**MSOX4032A-01**

**S E R V I C E N O T E**

4000 X-Series Scopes

**A replacement of the power supply cover is needed when the cabinet assembly is replaced.**

Old revision cabinet

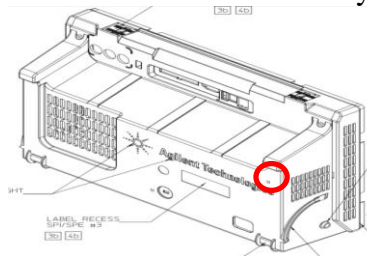
1. If the cabinet assembly (54709-64401) needs to be replaced, check if it is the old revision or the new revision
  - a. Old revision has 3 screw holes
  - b. New revision has 4 screw holes

2. If the cabinet assembly is the new revision, proceed with repair as normal
3. If the cabinet assembly is the old revision
  - a. Replace the power supply cover (54695-00103) with new revision
  - b. Replace cabinet assembly as usual (54709-64401)
  - c. Insert screw (0515-0380) into the new screw hole on the cabinet assembly (circled below)
